CORRIGENDUM- 05

PROJECT	:	(3X200 MW+3x500 MW) RAMAGUNDAM STAGE-I & II FGD
PACKAGE	:	GYPSUM DEWATERING SYSTEM
TENDER ENQUIRY NO	:	PE/PG/RGM/E-6515/2020 Dt. 05/09/2020
SUBJECT	:	REGARDING REPLY OF PRE BID QUERY

PRE BID CLARIFICATIONS - 1

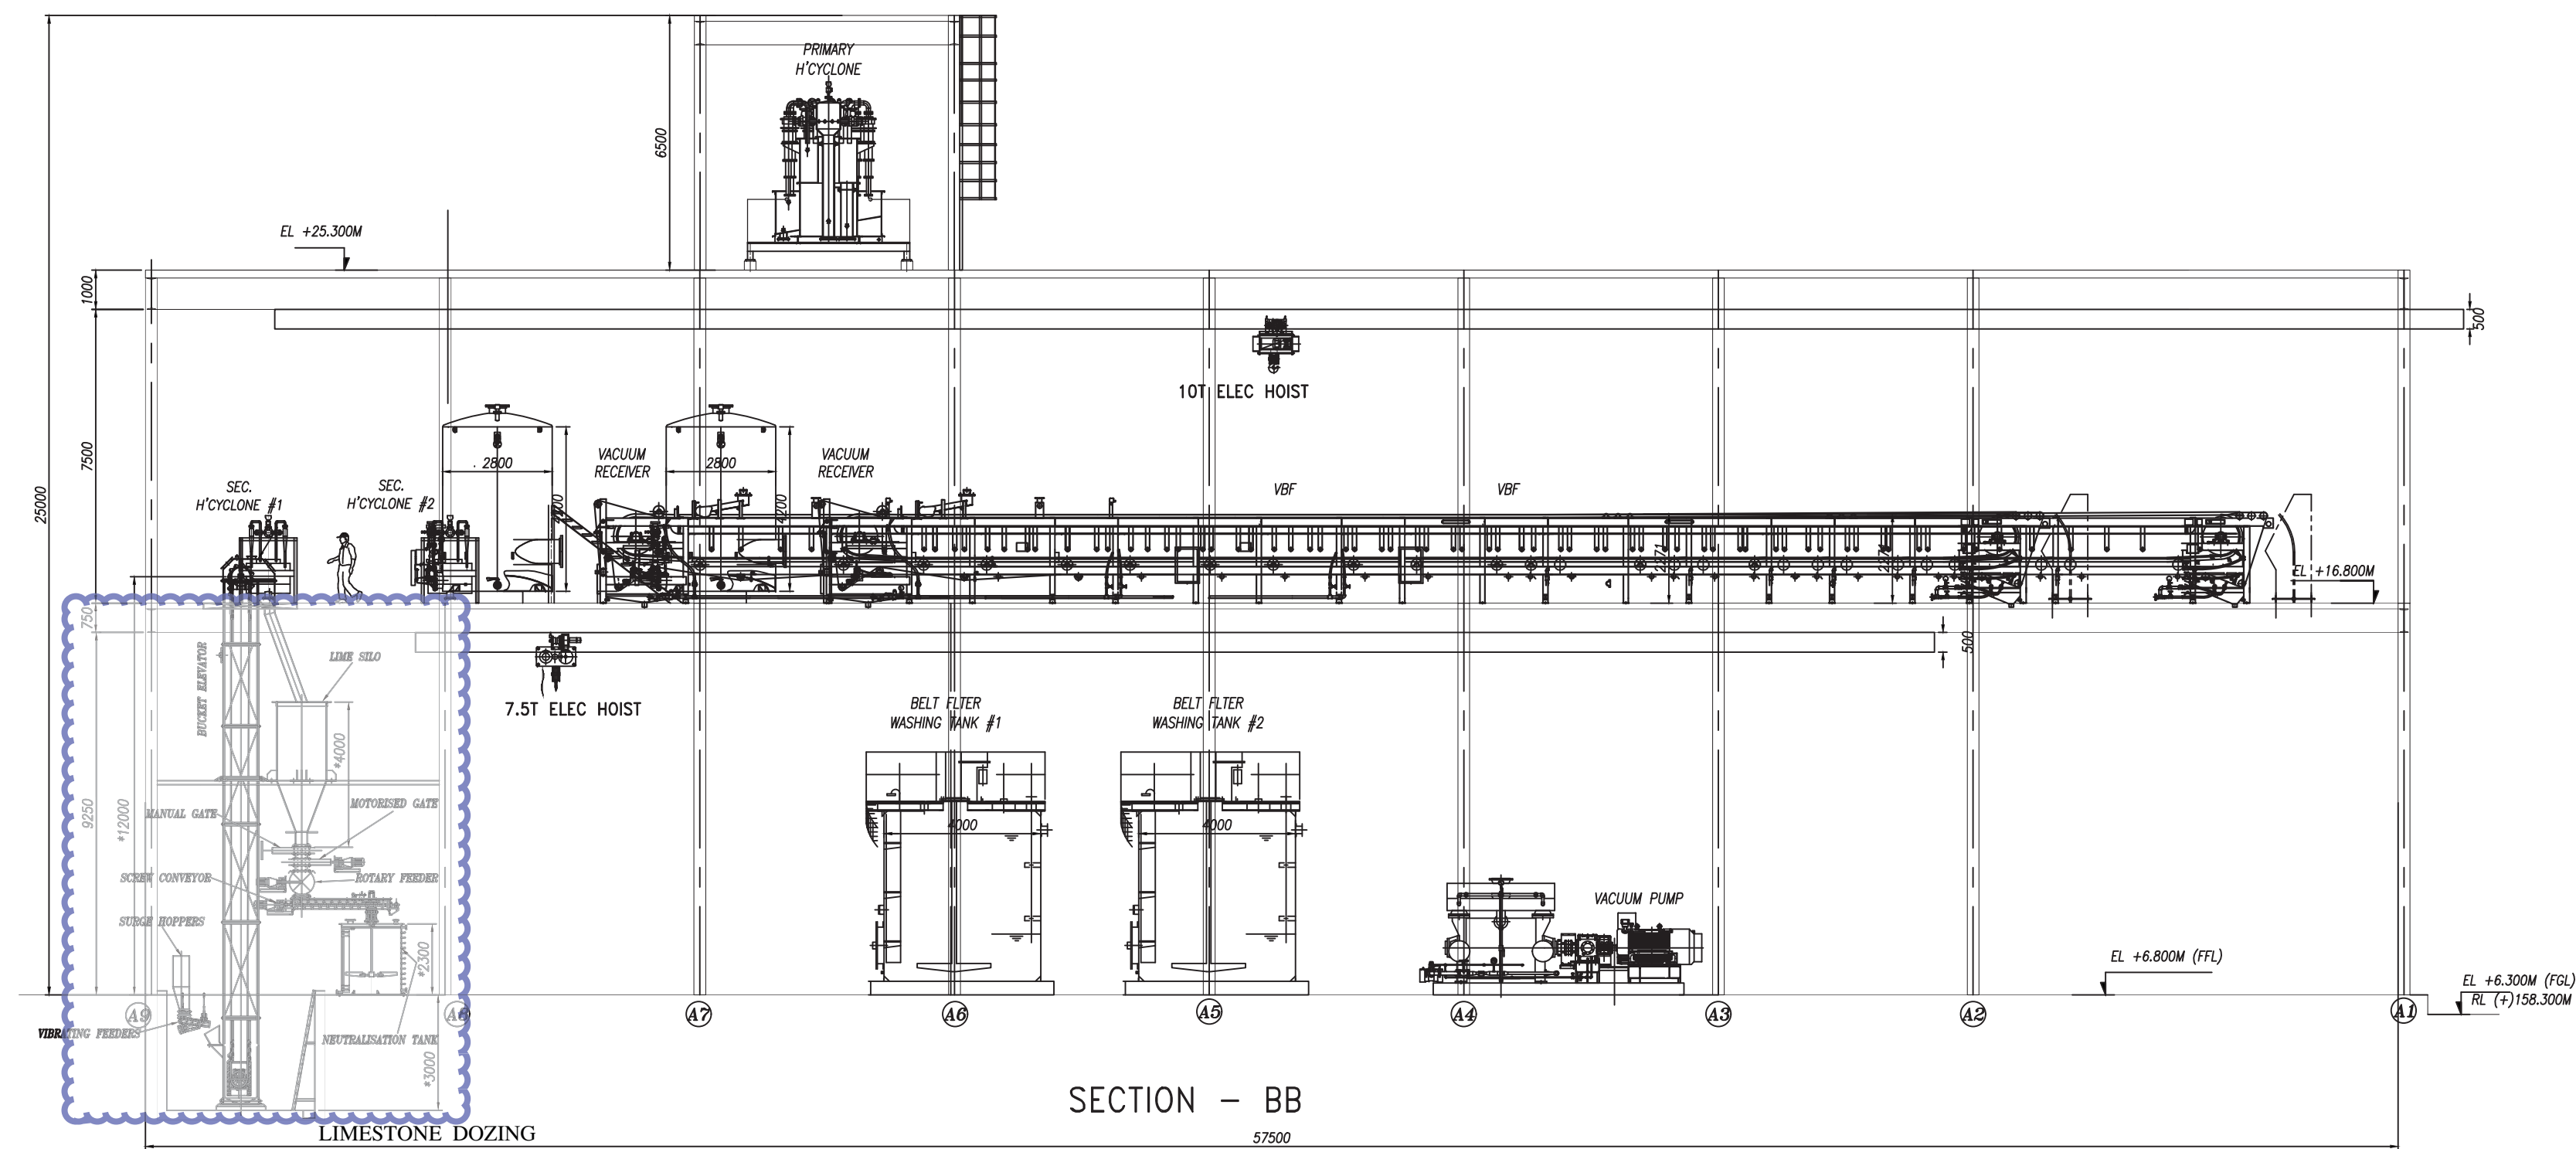
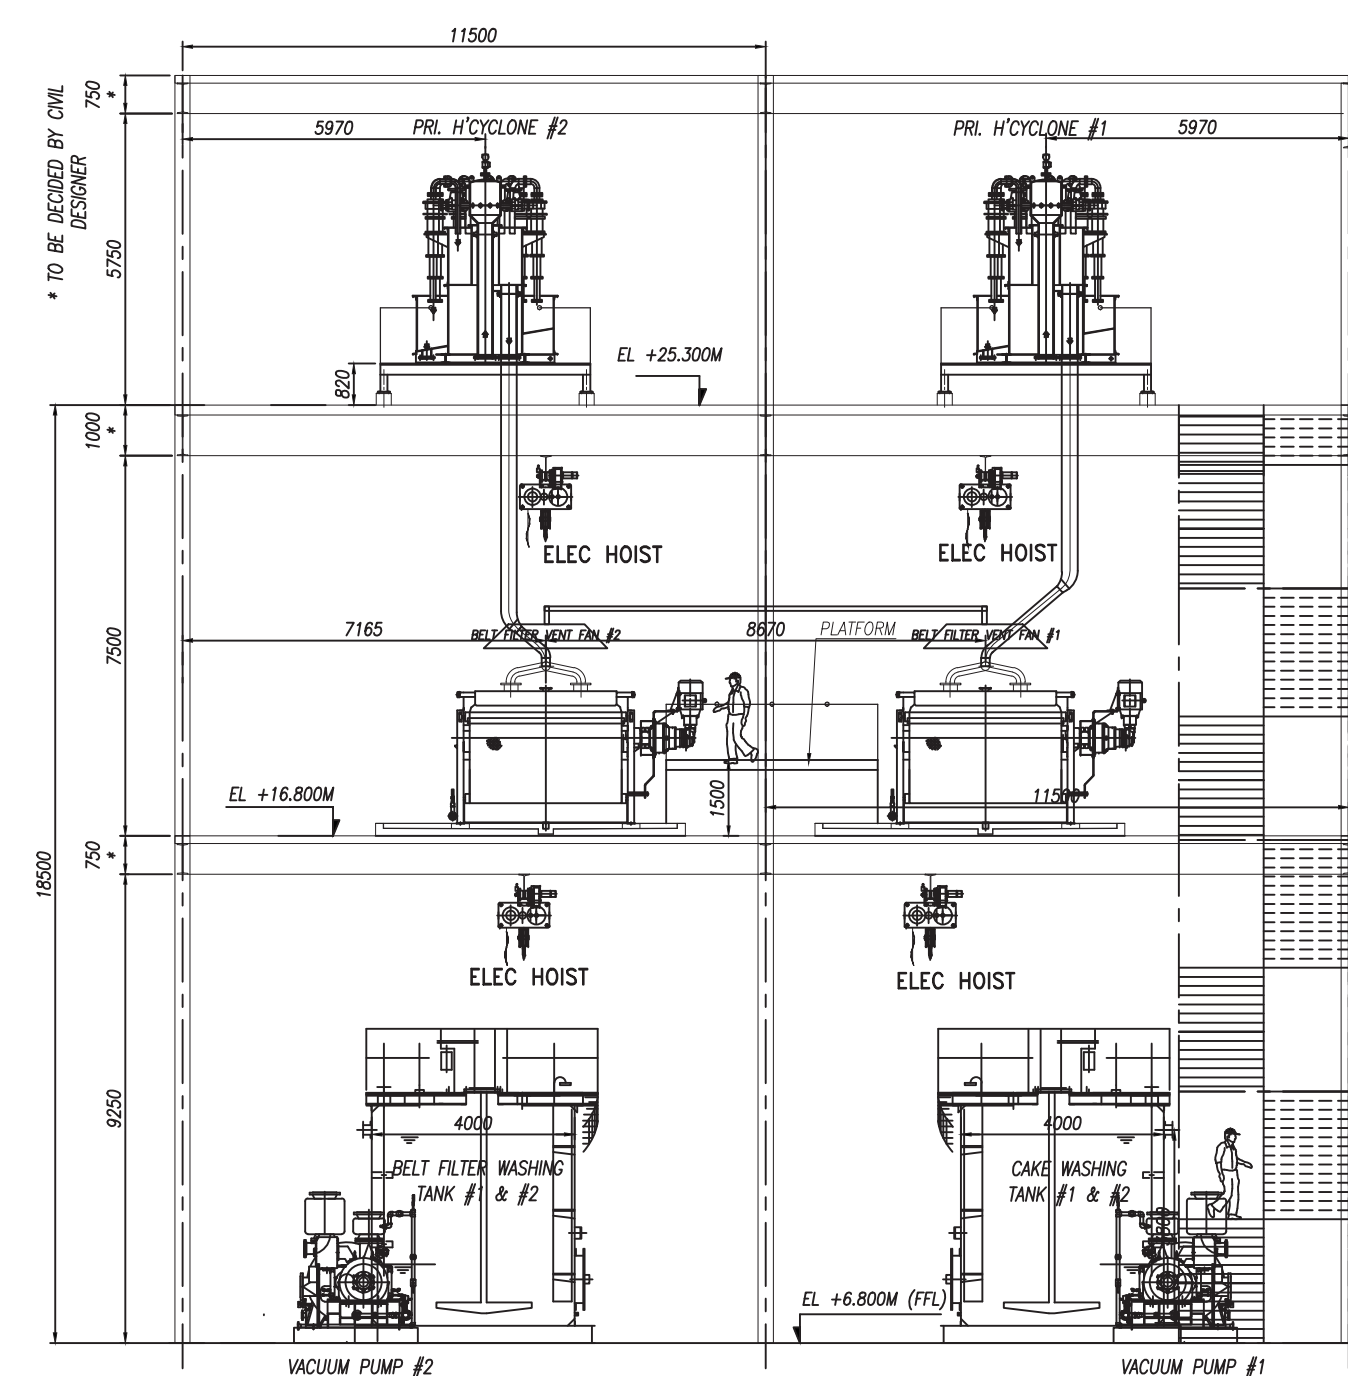
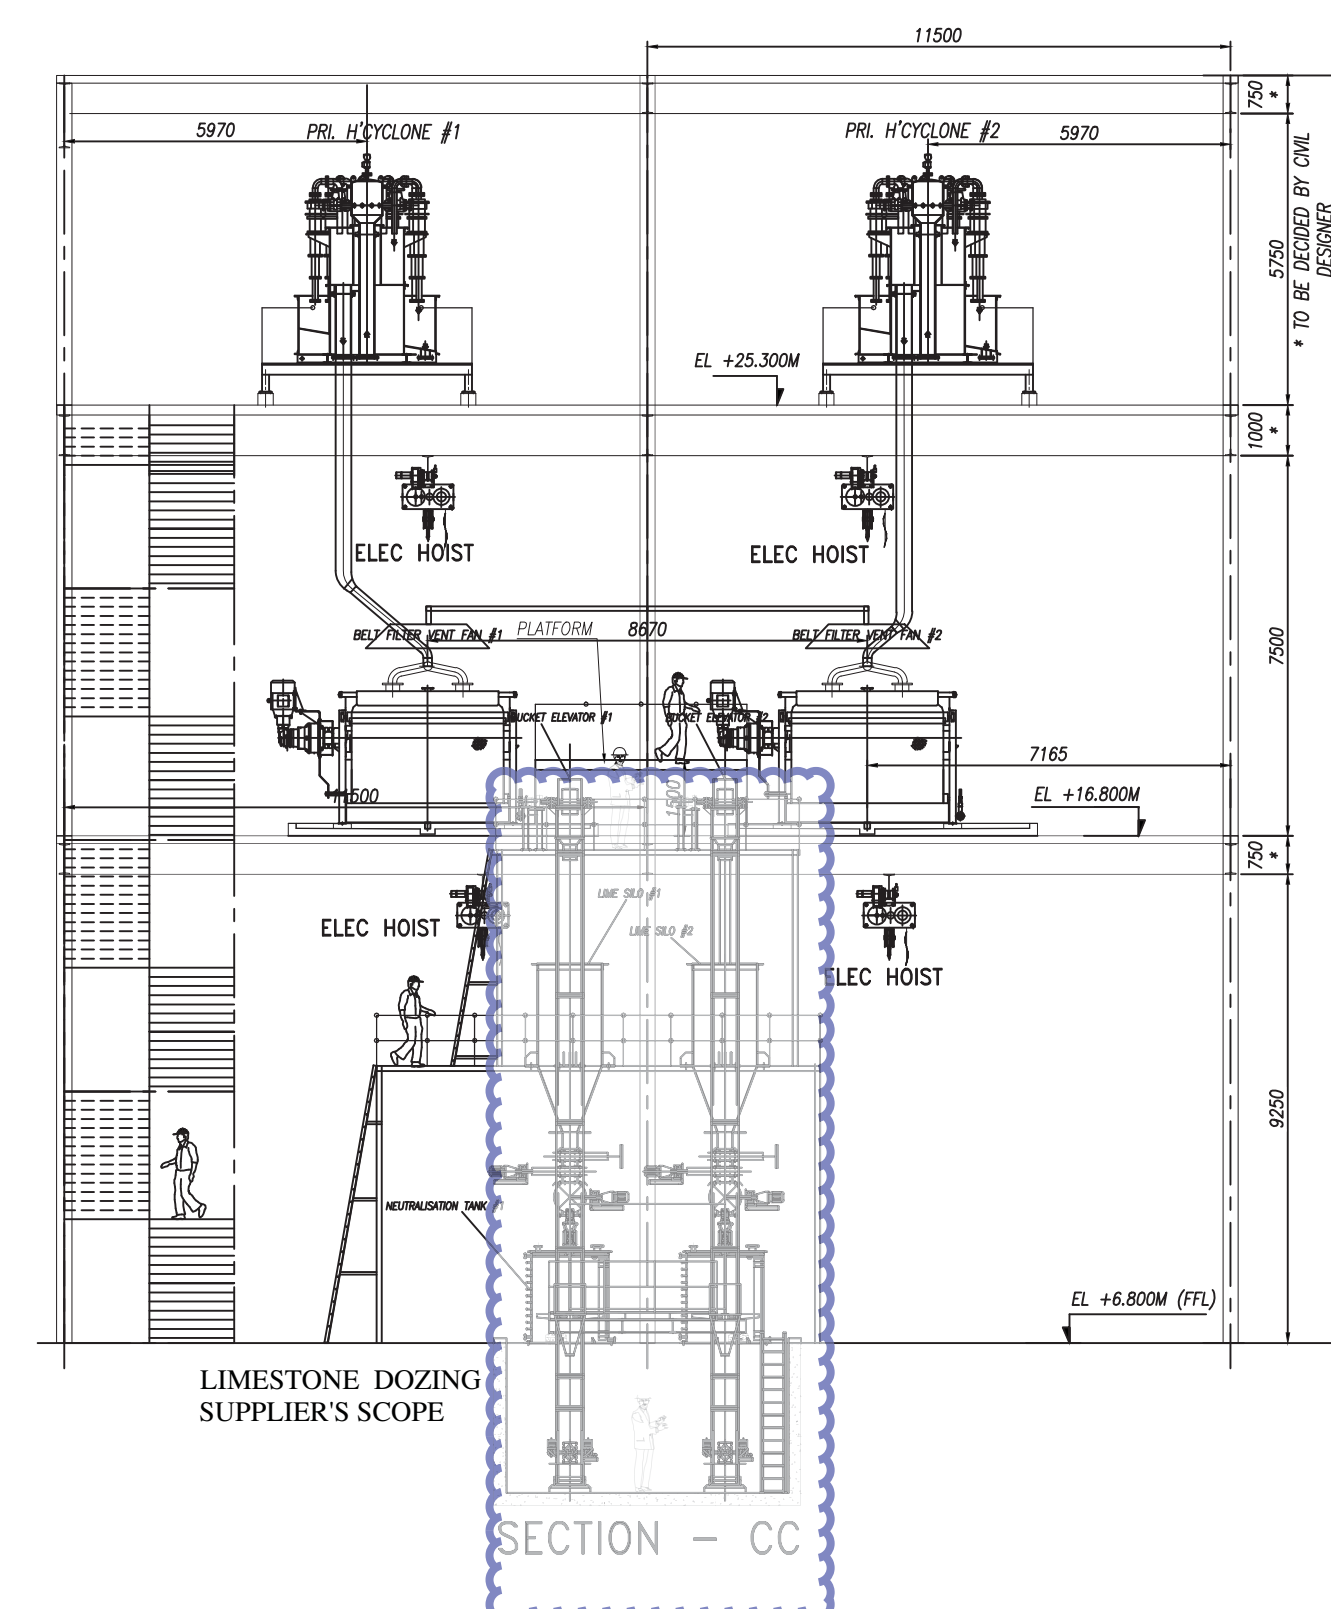
45		412 of 537	Elevation view of conveyor is not provided in layout	Client to provide the same	Extracts of elevation view of conveyor attached for reference as Annexure-B to this pre-bid clarifications.
